# UNITED STATES PATENT AND TRADEMARK OFFICE

APPLICATION NO.	FILING DATE	FIRST NAMED INVENTOR	ATTORNEY DOCKET NO.	CONFIRMATION NO.
10/811,695	03/29/2004	Mark James Kline	9595	1368

<b>Office Action Summary</b>	<b>Application No.</b> 10/811,695	<b>Applicant(s)</b> KLINE ET AL.	
	<b>Examiner</b> Michael G. Bogart	<b>Art Unit</b> 3761

## **DETAILED ACTION**

**Fig. 2**

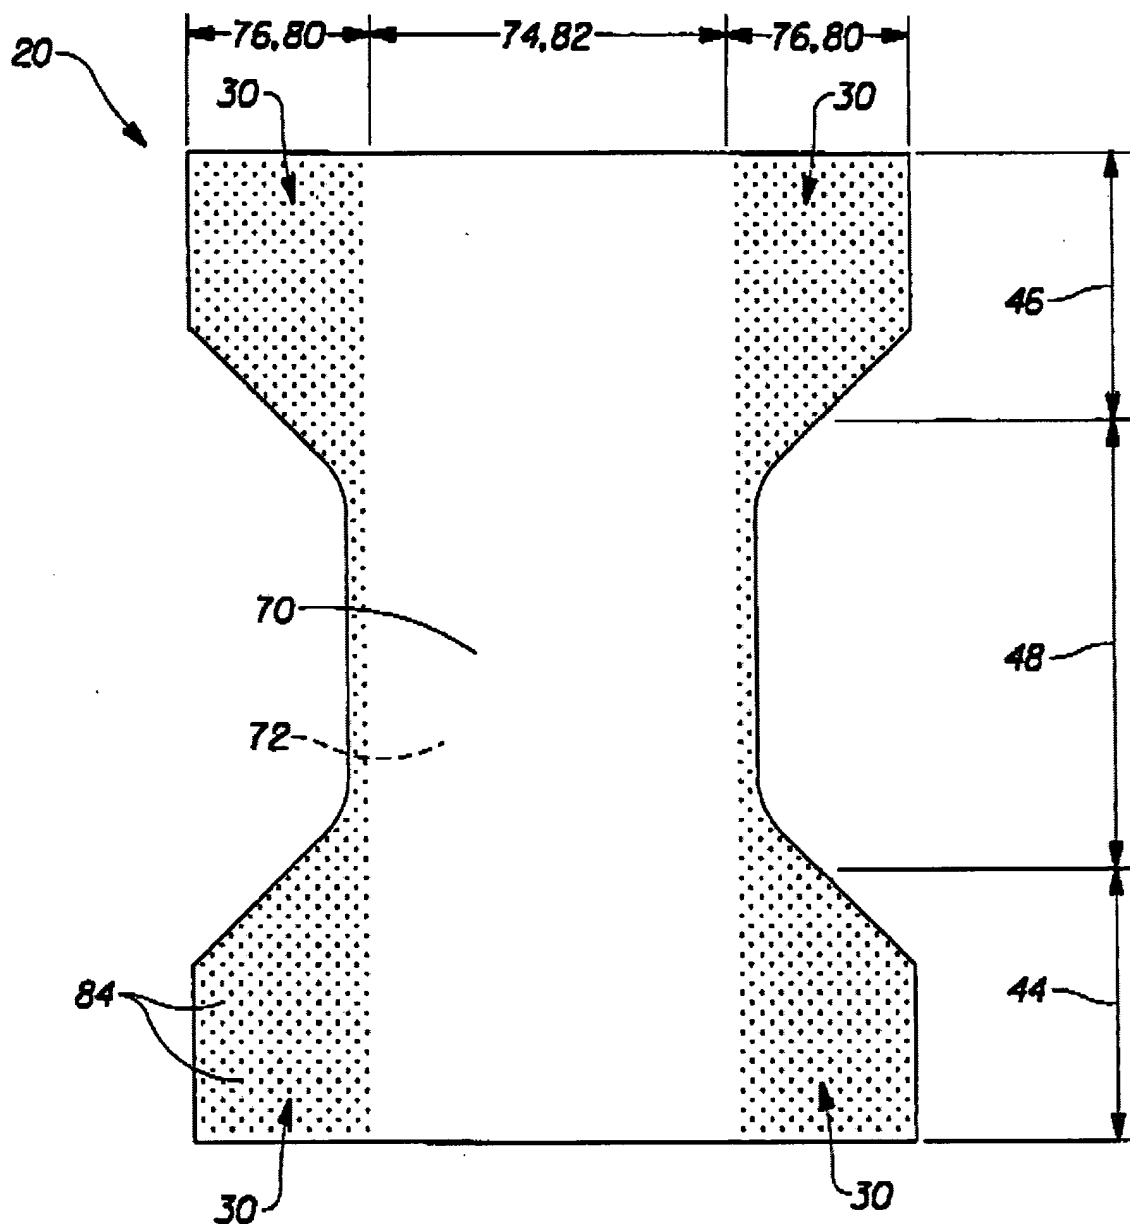
a liquid impermeable backsheet (26) positioned adjacent said garment-facing surface of said absorbent core (28); said backsheet (26) having a physical variation along at least one axis, wherein said physical variation defines a first backsheet zone (74) and a second backsheet zone (76), wherein said physical variation is a measurable difference, wherein said physical variation is as measured by a physical property selected from the group consisting of basis weight, thickness, density and tensile modulus; at least one elastomeric element (34) having at least one primary direction of stretch, said elastomeric element (34) at least partially overlapping and joined to said second backsheet zone (76);

a first stretch region (44) having lateral stretch; and

a second stretch region (46) having lateral stretch; wherein said first stretch region is co-elongatable with said second stretch region (see figure 2, *infra*). The limitation concerning the co-stretchability of the elastic elements is functional. An apparatus claim must be structurally distinguishable over the prior art. MPEP § 2114.

The unperforated portion (74) of the backsheet (26) has a greater basis weight and density than the perforated portions (76).

Regarding claim 3, the first stretch region (44) includes second backsheet (76) zone.

Regarding claim 4, second stretch region (46) includes at least one ear (30).

Regarding claim 8, Dobrin teaches a front waist region (46) back waist region (44), a crotch region (48) a buttocks region (rear portion of crotch (48)) near rear waist region (44);

said first backsheet zone (74) being primarily located in said crotch and front waist region (46), wherein the second backsheet zone (76) is located partially in the back waist region (44).

Regarding claim 9, Dobrin teaches a front waist region (46) back waist region (44), a crotch region (48) a buttocks region (rear portion of crotch (48)) near rear waist region (44); said first backsheet zone (74) being primarily located in said crotch and front waist region (46), wherein the second backsheet zone (76) is located partially in the buttocks region.

Regarding claim 11, the second backsheet zone (76) has a lower basis weight and density that the first backsheet zone (74).

Fig. 1

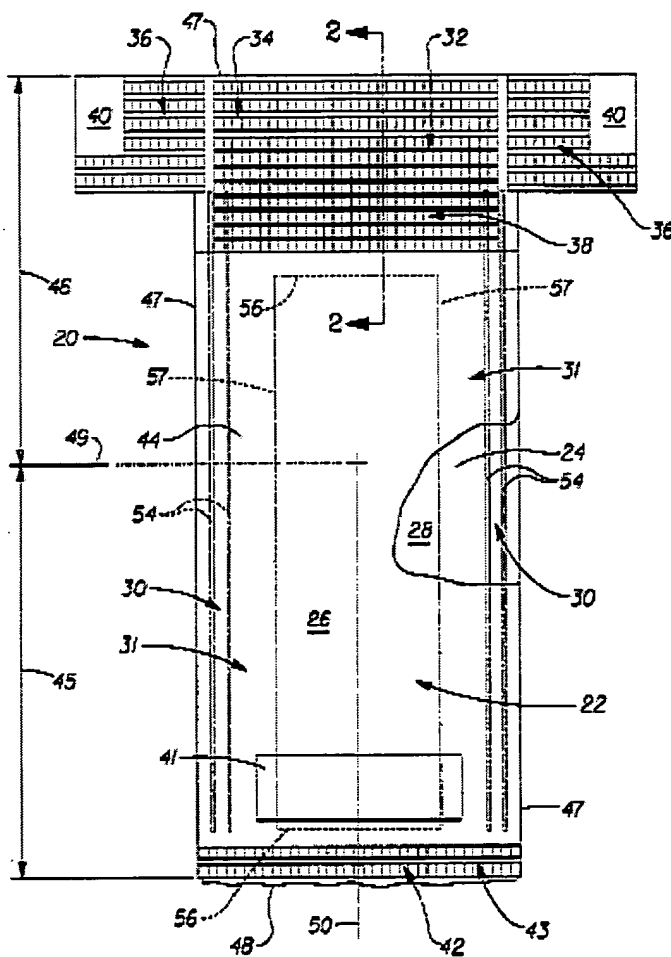
a liquid impermeable backsheet (26) positioned adjacent said garment-facing surface of said absorbent core (28); said backsheet (26) having a physical variation along at least one axis, wherein said physical variation defines a first backsheet zone (34) and a second backsheet zone (crotch region), wherein said physical variation is a measurable difference, wherein said physical variation is as measured by a physical property selected from the group consisting of basis weight, thickness, density and tensile modulus; at least one elastomeric element (54) having at

least one primary direction of stretch, said elastomeric element (54) at least partially overlapping and joined to said second backsheet zone;

a first stretch region (34) having lateral stretch; and

a second stretch region (43) having lateral stretch; wherein said first stretch region is co-elongatable with said second stretch region (see figure 1, infra).

The limitation concerning the co-stretchability of the elastic elements is functional. An apparatus claim must be structurally distinguishable over the prior art. MPEP § 2114.

Zones (32) and the backsheet at the central crotch region differ in their tensile modulus.

Regarding claim 6, (34) and the crotch portion overlap the longitudinal axis.

Regarding claims 14 and 16, Roe teaches a third backsheet zone (38) having a different than the other backsheet zone (34) and the crotch portion such that its extension forces are less than that of (32) but greater than that of the crotch region.
